South Texas Project Electric Generating Station P.O. Box 282 Wadsworth, Texas 77483

September 21, 2009
U7-C-STP-NRC-090146

South Texas Project
Units 3 and 4
Docket Nos. 52-012 and 52-013
Responses to Requests for Additional Information

Attached are responses to NRC staff questions in Request for Additional Information (RAI) letter number 202, related to COLA Part 2, Tier 2, Sections 2.4S.12, "Groundwater," 2.5S.2, "Vibratory Ground Motion," and 2.5S.4, "Stability of Subsurface Materials and Foundations."

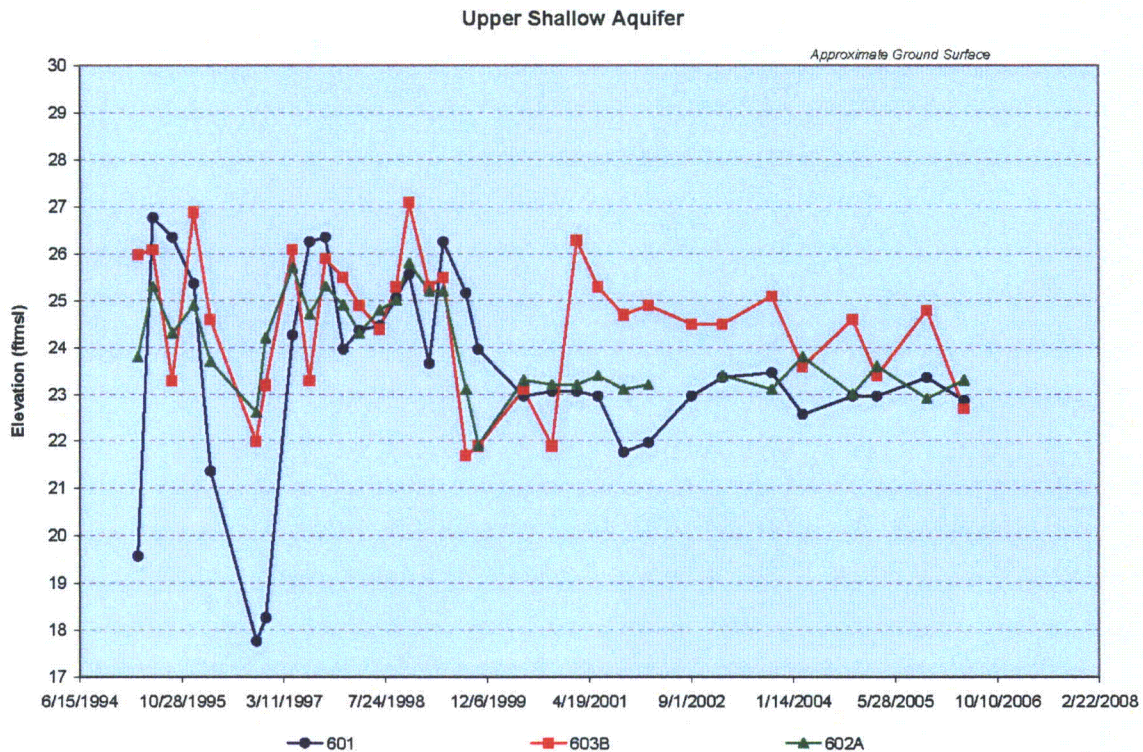
In its review of the applicant’s responses to RAIs 02.04.12-08 and 02.04.12-26, and FSAR Rev 2 Section 2.4S.12.2.3, “Temporal Groundwater Trends”, the staff noted that the applicant, STP, described Well 602A data as though it is presented in FSAR Rev 2 Figure 2.4S.12-23; however, the data is not presented in the figure. Revise FSAR Rev 2 Figure 2.4S.12-23 to include the Well 602A data.

FSAR Figure 2.4S.12-23 will be revised to include the hydrograph from Well 602A, which is shown below. This revised Upper Shallow Aquifer hydrograph will replace the existing top-left hydrograph in FSAR Revision 3, Figure 2.4S.12-23, and ER Revision 3, Figure 2.3.1-28, in a future COLA Revision.

Figure 2.4S.12-17 Shallow Aquifer Potentiometric Surface Maps

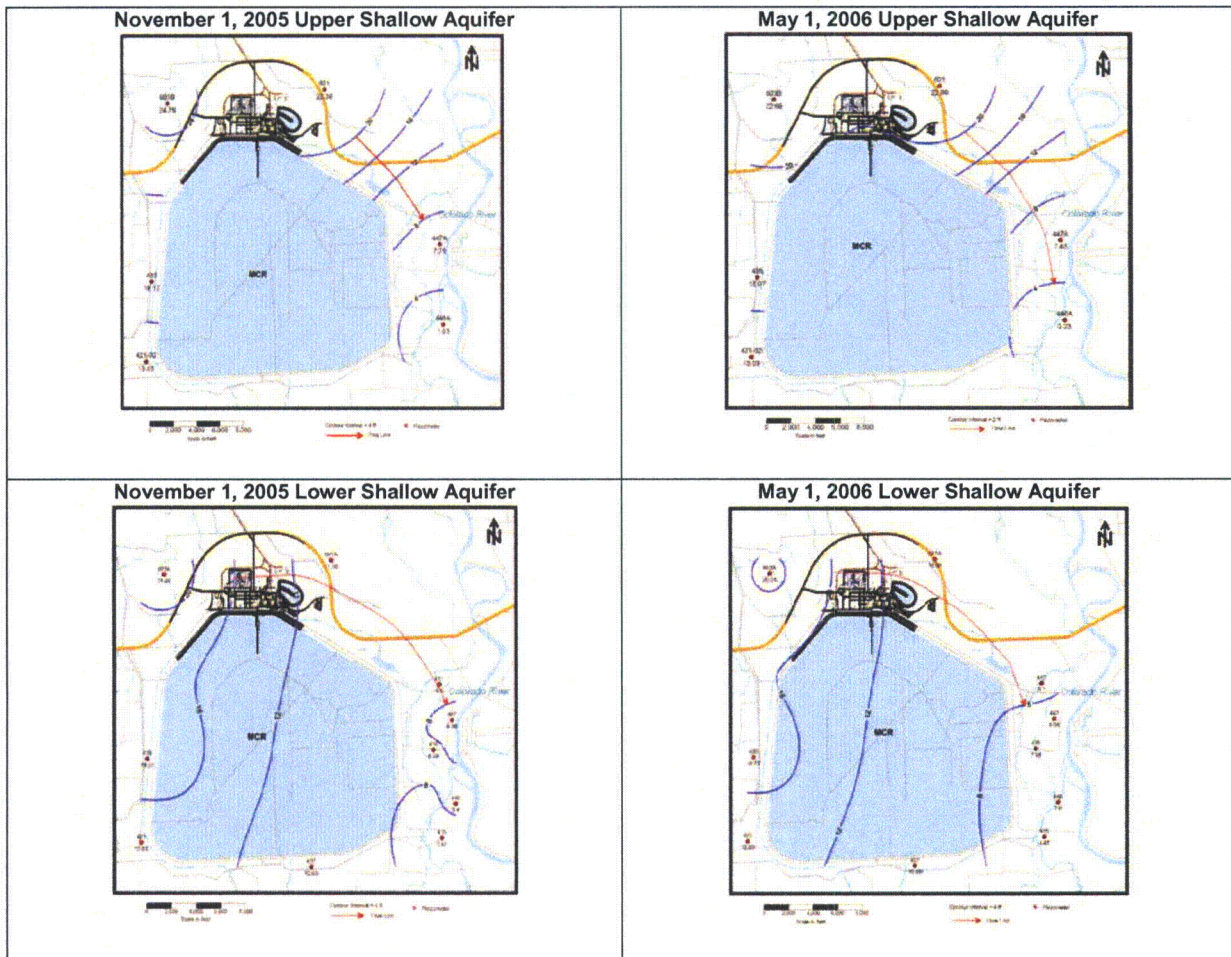
In the review of (1) the FSAR Rev 2 Sections 2.4S.12.1.4, "Site-Specific Hydrogeology" and 2.4S.12.2.2, "Groundwater Flow Directions", (2) the applicant's response to RAI 02.04.12-09, (3) amendments to FSAR Section 2.4S.12.2.2 noted in the applicant's responses to RAI 02.04.13-4 and 02.04.12-6, (4) revised responses to ER RAIs 02.03-07 and 02.03-08, and (5) remarks contained in the groundwater model development and analysis report (see Section 2.4 on site groundwater levels), the staff note that the reviewed sections, (i.e., FSAR 2.4S.12.1.4 and 2.4S.12.2.2), require update to include current site characterization information and conclusions with regard to plausible pathways, mounding, gradients (including those to southwest), and maps showing the full seasonal variation of groundwater levels through 2008. Note especially conclusions in response to ER RAI 02.03-07 (see "third step" on pages 4 and 5 of 6 where applicant acknowledges flow to southwest, mounding in both Upper and Lower Shallow aquifers, and communication with Kelly Lake to the southeast.) Note also that the labeling of FSAR Figure 2.4S.12-17 is either incomplete or illegible (labeling of aquifers and dates).

With regard to the labeling of FSAR Figure 2.4S.12-17, the subtitles for FSAR Figures 2.4S.12-17, and also 2.4S.12-18, were inadvertently removed between STP COLA Revisions 1 and 2. The figures with the corrected subtitles are provided below and will be included in a subsequent COLA revision.

Figure 1 - Observation Wells Sampled in the STP 1 & 2 Protected Area

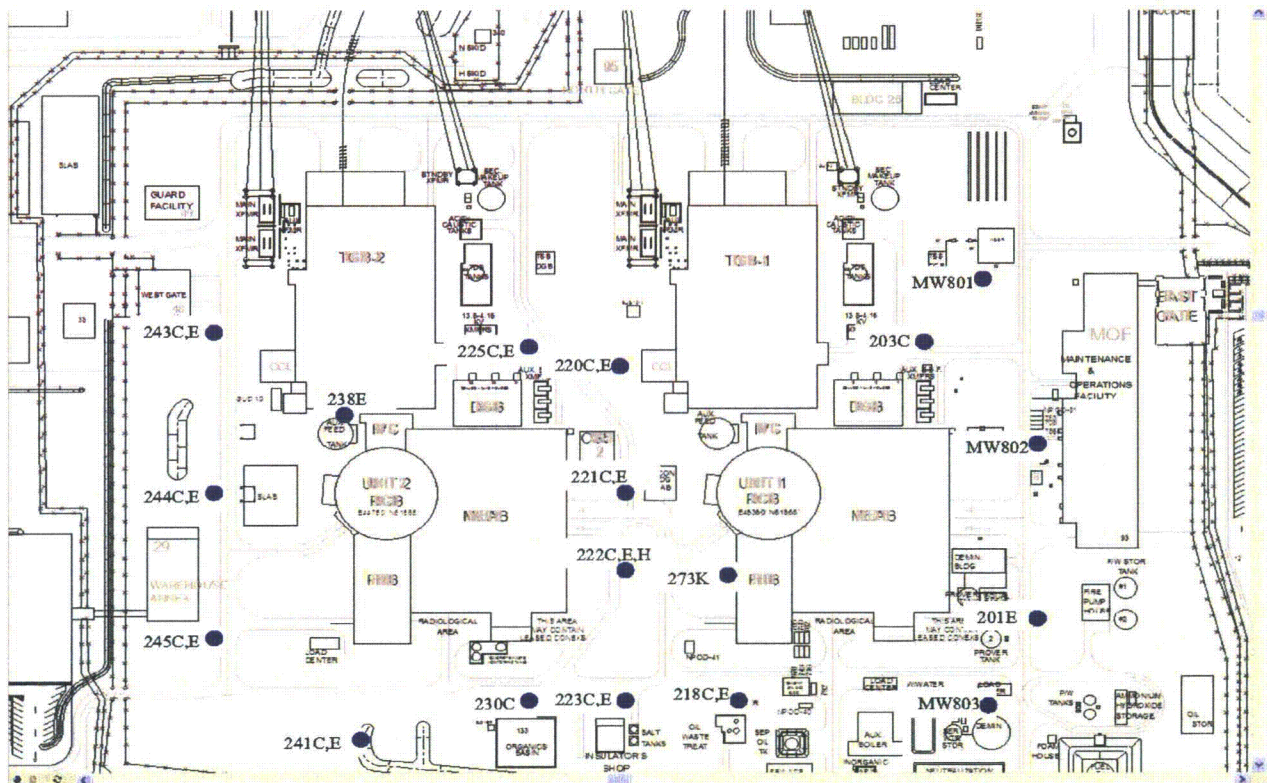
In the review of the applicant's response to RAI 02.04.12-17, including review of FSAR Rev 2 Sections 2.4S.12.3.1, 2.4S.12.3.2, and 2.4.S.13.1.2, and the response to RAI 02.04.12-1, the staff noted the applicant has considered information in the Annual Environmental Operating Report (no specific report cited) to determine the site conceptual model. In staff's review of the applicant's Annual Environmental Operating Report for 2006 (issued April 2007), staff note that sixteen shallow aquifer wells were sampled for various radionuclide concentrations within the Protected Area. Since some values were detected above laboratory detection limits but were below the EPA drinking water standard, the following information is requested: Provide the well location and screen depth/interval of all wells that drew samples from the Upper Shallow Aquifer (or a relatively shallow depth near the facilities) and the location and screen depth/interval of wells that drew samples from the Lower Shallow Aquifer (or a relatively deep depth near the facilities). Comment on whether these data support or refute the assumption that releases will be forced downward into the Lower Shallow Aquifer by a downward hydraulic gradient. Revise the site conceptual model described in Section 2.4S.12.3.1, "Exposure Point and Pathway Evaluation", and Section 2.4S.13.1.2, "Conceptual Model" to reflect these observed contamination levels, their relative position, and whether they support or refute the existing conceptual model, (i.e., groundwater contamination moves from Upper to Lower Shallow Aquifer).

Table 1 provided below lists the screen-depth interval and tritium concentrations of 29 observation wells sampled quarterly in the STP 1 & 2 protected area over the past several years. Six shallow-deep well pairs (218 C&E; 220 C&E; 221 C&E; 223 C&E; 241 C&E and 245 C&E) and one shallow-deep well triplet (222 C, E&H) are listed in Table 1 and the locations of each of the listed wells are shown in Figure 1. In five of the six well clusters, measured tritium concentrations are greater in the deeper well. It can be noted that most of the protected area was excavated to a maximum depth of approximately 60 feet below grade to allow construction of deep foundations for various safety-related structures. Therefore, many of the observation wells within the protected area are completed within or adjacent to structural fill. The observed distribution of tritium concentrations is consistent with the site conceptual model that asserts: due to the pervasive downward vertical hydraulic gradient, releases to the Upper Shallow aquifer will flow downward to the Lower Shallow aquifer where the hydraulic conductivity of the material separating the aquifers is conducive to downward flow.

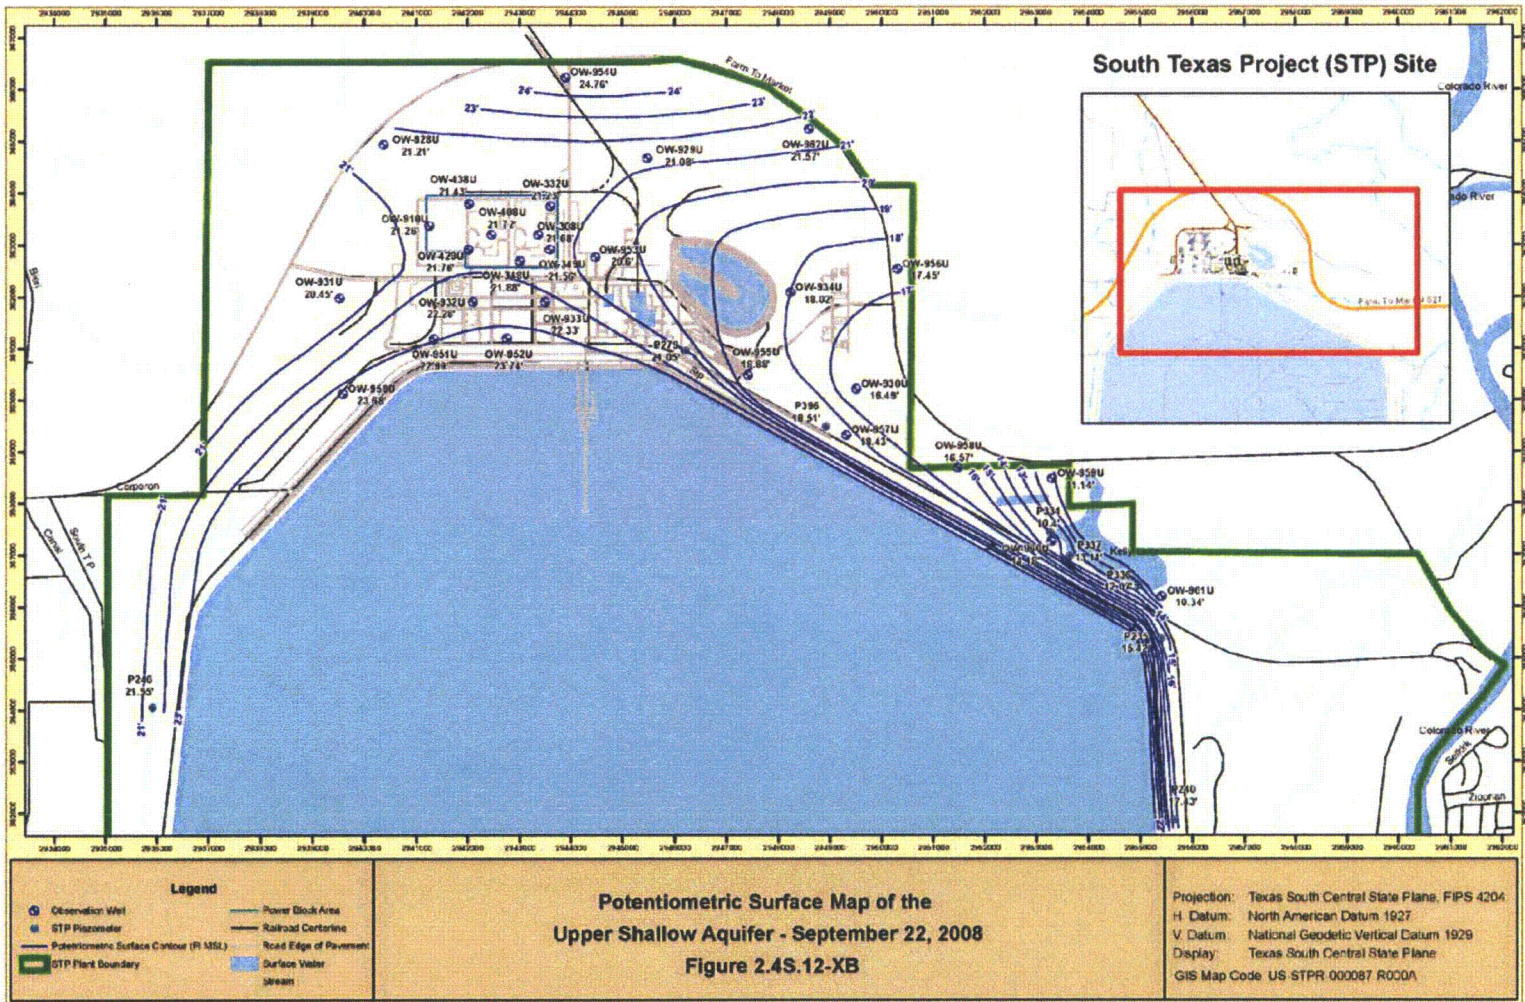
In the review of the applicant's response to RAI 02.04.12-20, the staff noted the applicant, STP, (1) did not provide a copy of Figure 2.4S.12-XB, (2) noted the application of Visual MODFLOW to create and apply a site-specific groundwater model, and (3) commitment to future FSAR revisions that were not provided. The staff request (1) a copy of Figure 2.4S.12-XB, (2) copies of input and output representative of the Visual MODFLOW simulations completed and significant to conceptualizing the site and simulating plausible alternative transport pathways applied in FSAR Section 2.4.13, and (3) copies of proposed revisions to FSAR Sections 2.4.12 and Section 2.4.13 text, tables, and figures in response to RAI 02.04.12-20 and the completed groundwater model simulations.

- (1) A copy of Figure 2.4S.12-XB is included with this response.
- (2) Input and output files representative of the Visual MODFLOW simulations are provided on the enclosed DVDs.
- (3) The COLA revisions in response to RAI 02.04.12-20 have been incorporated into STP COLA Revision 3. The completed groundwater model simulations are included in Reference 1.

Figure 1: 1995 Blessing SE, TX USGS 7 1/2-minute topographic map.

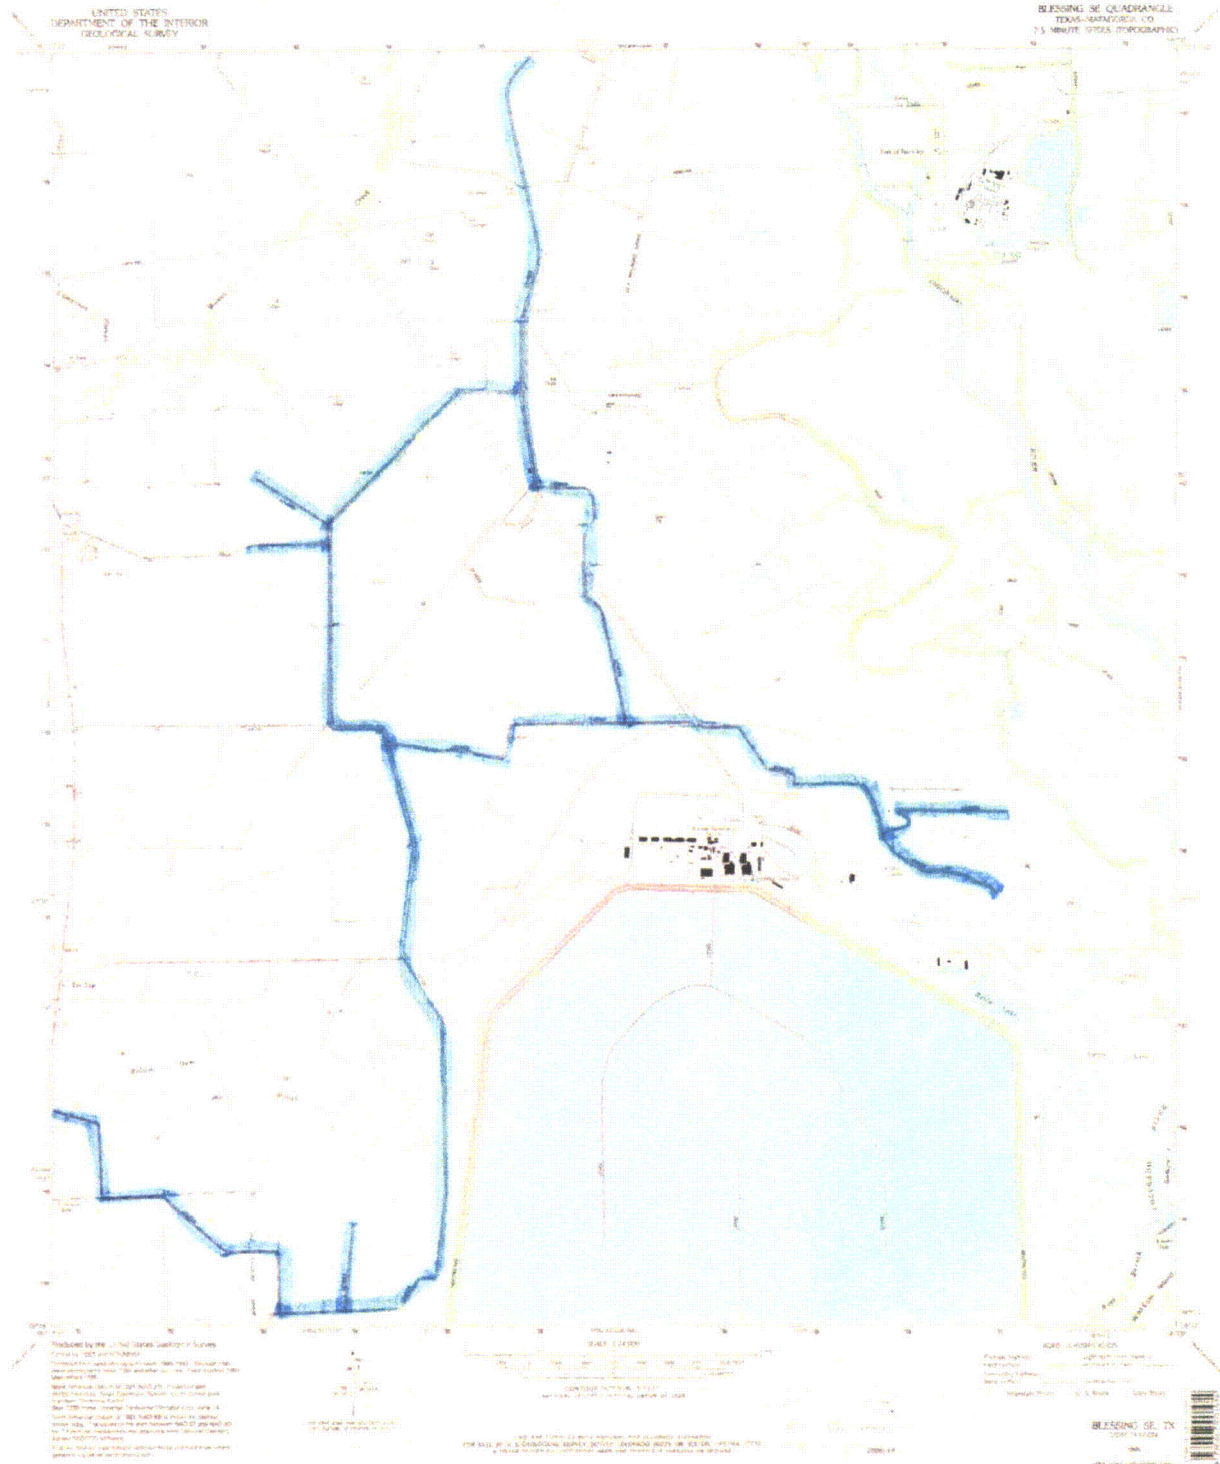
In the review of the document “Groundwater Model Development and Analysis for STP Units 3&4” provided as part of applicant’s response to RAI 02.04.12.20, the staff noted that while the purpose of a groundwater flow model for a site goes beyond just calibration, one of the primary bases for determining a model’s reliability to predict post-construction conditions is documenting its ability to reproduce existing field observation. The staff conclude from the review (of the FSAR Rev 2 Sections 2.4S.12 and 2.4S.13, and RAI responses including 2008 data and interpretations) that among the critical observed field conditions not reproduced by the existing model one must include (1) a groundwater divide in the Upper Shallow Aquifer in the immediate vicinity of the proposed location for STP Units 3&4, (2) a groundwater divide (that can not be excluded) in the Lower Shallow Aquifer in the immediate vicinity of the proposed location for STP Units 3&4, and (3) an exposure pathway in the vicinity of Kelly Lake where there is an upward gradient from the Lower to the Upper Shallow Aquifer and the Upper Shallow Aquifer is hydraulically connected to Kelly Lake. Provide either 1) a revised conceptual model to better represent the current observed field conditions, a revised numerical model, its revised results and conclusions, and proposed changes to the FSAR Sections 2.4.12 and 2.4.13, or 2) a justification of why these inconsistencies between observations and model predictions do not make the model unreliable for these assessments.

data indicate potential influence from the unnamed surface drainage features shown in Figure 44 of Reference 1 on the potentiometric surface of the Upper Shallow Aquifer, and that seasonal changes affect the appearance and formation of the divide (see June 29, 2008 map provided with response to RAI 02.04.12-28). Conceptually, the source from the north may include the flooded marshes, ponds, and the levee-bound irrigation channels located along and beyond the north site boundary, as depicted on the 1995 Blessing SE, TX USGS 7½-minute topographic map provided as Figure 1 below.

The highlighted features of this map show levee-bound agricultural irrigation channels along the north and west site boundaries that provide water to local agricultural field-irrigation siphons by routing the water through the channels at elevated heads with respect to the land surface. Unlike the flooded marshes and ponds, these irrigation channels can be assumed to penetrate to the Upper Shallow Aquifer (layer 2 of the numerical model) considering construction of the levees likely required the layer 1 clay to be removed from the excavated channel to a depth where communication with the Upper Shallow Aquifer would occur. The irrigation channels are simulated in the current numerical model (Reference 1) as drain cells in layer 1 with a low conductance that greatly restricts communication with layer 2. However, conceptually it is plausible that these features actually function as a source and would be best represented in the numerical model by specified head cells with the head specified above land surface. This concept was tested by executing subsequent preliminary runs of the current numerical model. Results indicate that specified heads in layer 1 alone did not satisfactorily create the north source. However, when the specified head cells were extended to layer 2 to simulate an unlined irrigation channel in direct communication with layer 2, significant flow from the north occurred in the Upper Shallow Aquifer.

Figure 2.4S.12-32 Subsurface Hydrostatic Loading

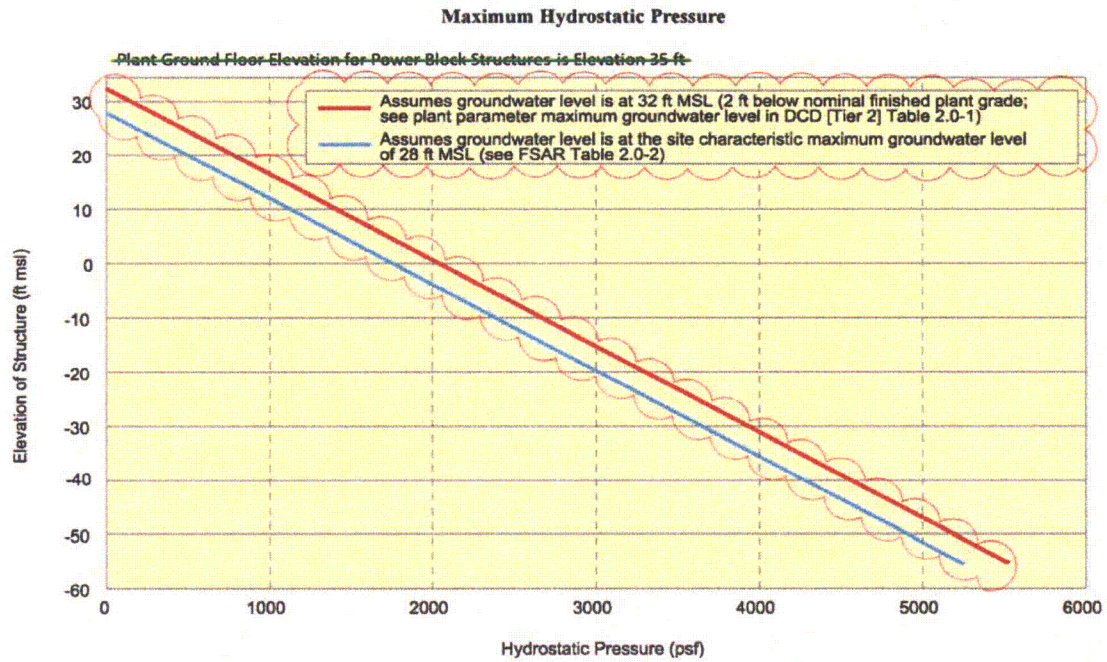
Instead of echoing the plant parameter "61.0 cm (2 ft) below grade" by rephrasing it as a site characteristic "> 61.0 cm (2 ft) below grade", NRC staff request a true site characteristic be assigned to the "maximum groundwater level" that provides some margin between site characteristic and the plant parameter. Also, with regard to the plant parameter for maximum groundwater level, clarify the "grade elevation" which is noted to be 35 ft MSL in Section 2.4S.12.5 and used to define the maximum groundwater level in the plant parameter, versus the "plant grade" which is defined to be 34 ft MSL in other subsections of Section 2.4S and elsewhere in the FSAR. Since the grade within the powerblock varies from 36.5 to 32 ft MSL and the selection of 35 ft MSL seems arbitrary, why isn't the more rigorously defined and repeatedly cited "plant grade" used to define the maximum groundwater level?

FSAR (Tier 2) Section 2.4S.12.5 and Figure 2.4S.12-32 also will be revised to reflect the STP Units 3 and 4 site characteristic of 28 ft MSL for maximum groundwater level as discussed above. Specifically, the second of the two approaches used in FSAR (Tier 2) Section 2.4S.12.5 to evaluate subsurface hydrostatic loading estimates involved the use of the maximum groundwater level elevation – 25.85 ft MSL – observed during the period from December 2006 through June 2007. The second approach reflected in both FSAR (Tier 2) Section 2.4S.12.5 and Figure 2.4S.12-32 will be revised to use the site characteristic maximum groundwater level of 28 ft MSL instead of 25.85 ft MSL. With this change, the FSAR description of the two approaches will reflect the “margin” between the conservative evaluation of hydrostatic loading estimates using the ABWR DCD plant parameter (first approach) and the evaluation using the STP Units 3 and 4 site characteristic (second approach).

Figure 2.4S.12-32 presents a graph of building elevation versus hydrostatic pressure. Two lines are provided on the graph, one representing the upper bound condition using the DCD maximum groundwater level and the second using the ~~maximum-observed groundwater levelsite characteristic maximum groundwater level of 28 ft MSL~~ in the power block area.

FSAR (Tier 2) Figure 2.4S.12-32 will be revised as follows:
